SAFETY RELATED RECALL

Global Recall Action
Number: N964

Subject: Raised Air Intake Detachment	Publication No.: N964
	Model: Defender (LE)
	Model Year: 2020 - 2025
	Date of Issue: 11 February 2025

E377204

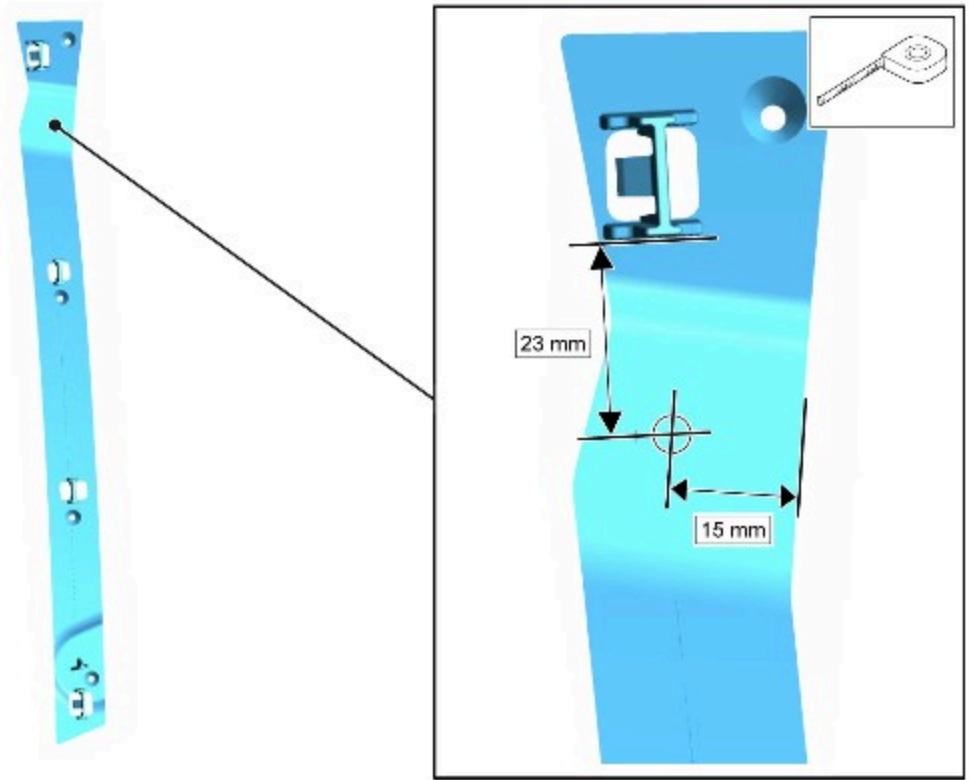
7. Measure and mark the area to be drilled, refer to the illustration.

E377206

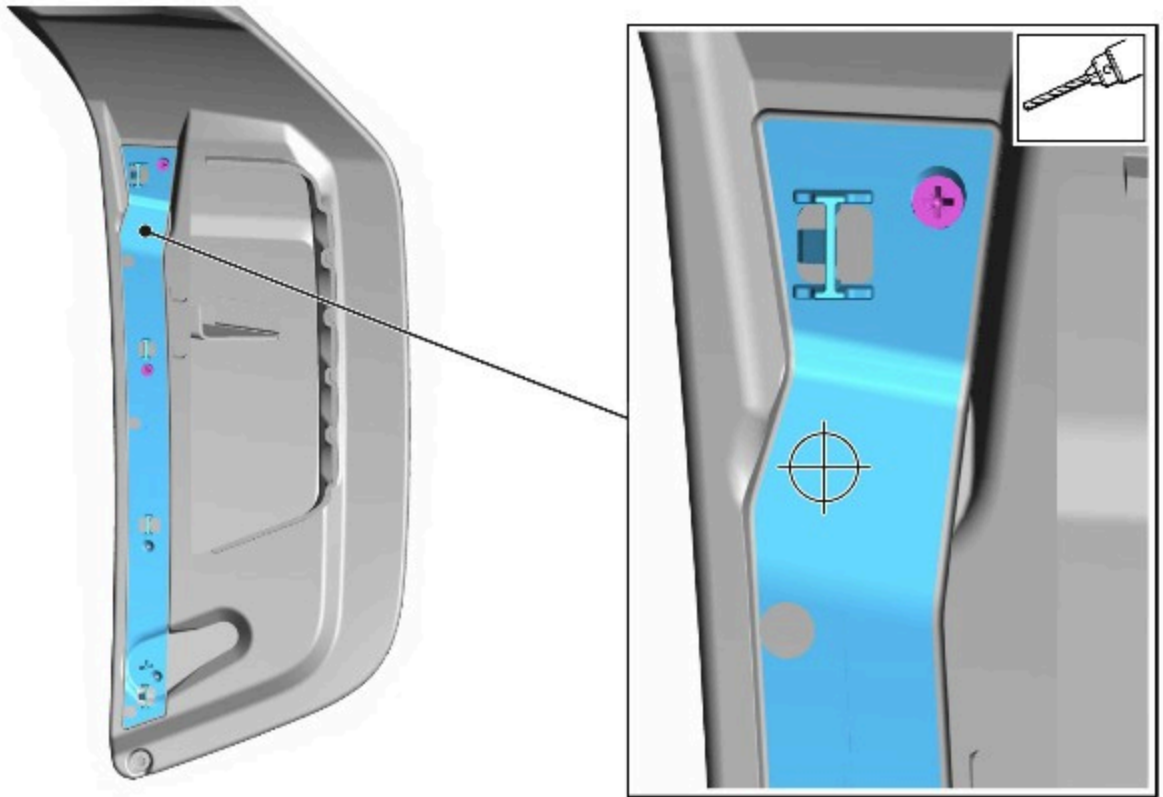
Do not drill through the outer body of the raised air intake.

Drill a pilot hole through the both the clip plate and raised air intake body.

- Using the 11 mm drill bit, drill through the clip plate and raised air intake body.

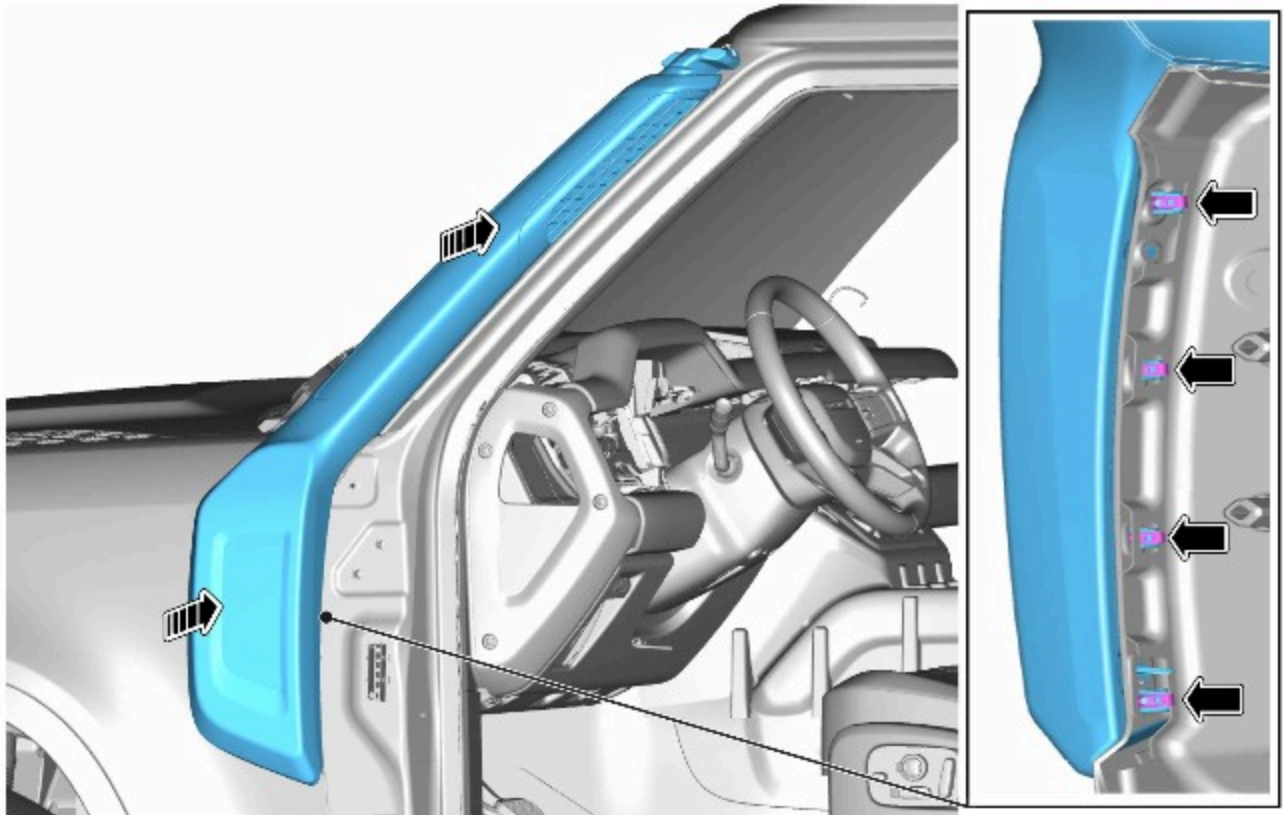
11. Install the Jack nut.

- Start the Jack nut installation using a RivNut installation tool.
- Continue to clamp the Jack nut manually using an M6 bolt to a torque of **3 Nm**.
- A visual check is required to make sure the Jack nut legs are splayed correctly.
 - Refer to the illustration, (1) shows the upperside of the installed Jack nut, (2) shows the lower side of the installed Jack nut.

E377212

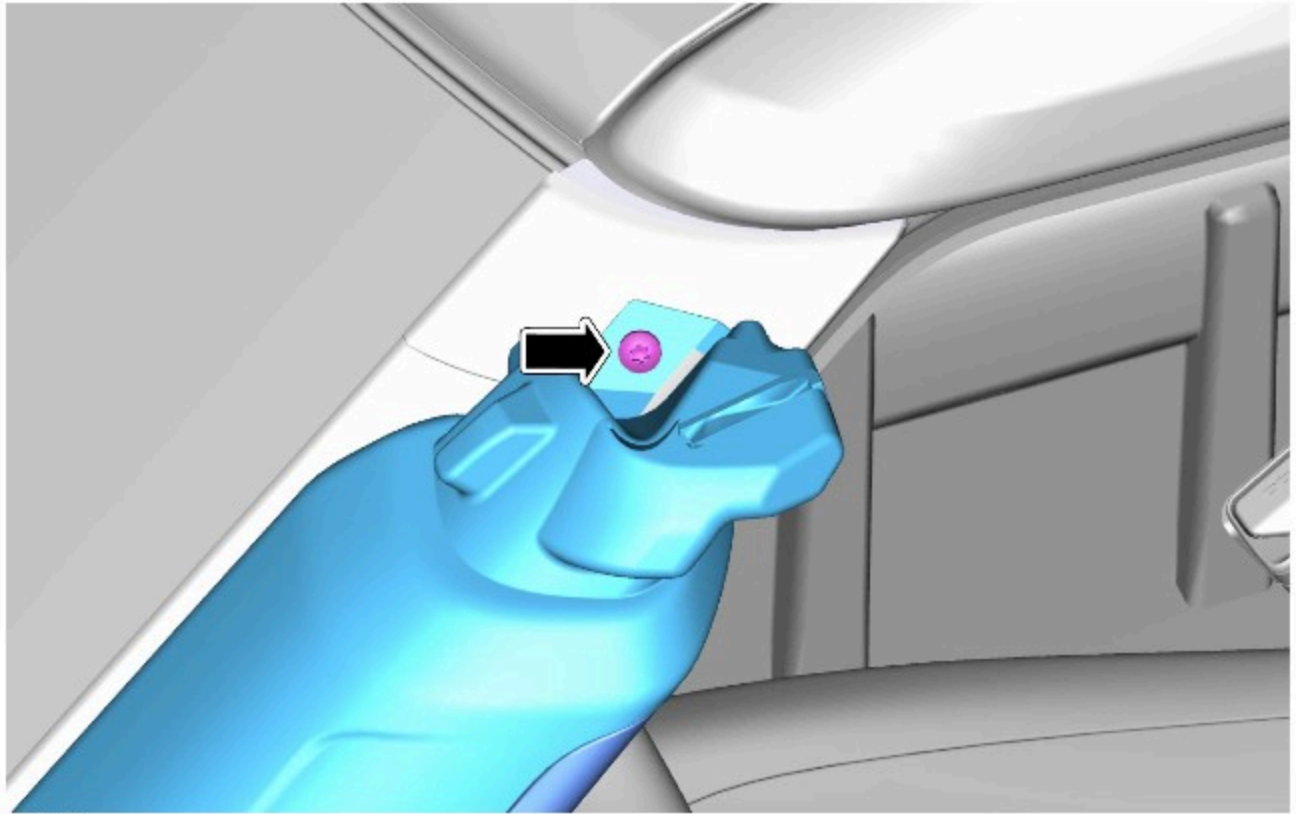
14. From the inside of the fender, install and partially tighten the new bolt LR091557.
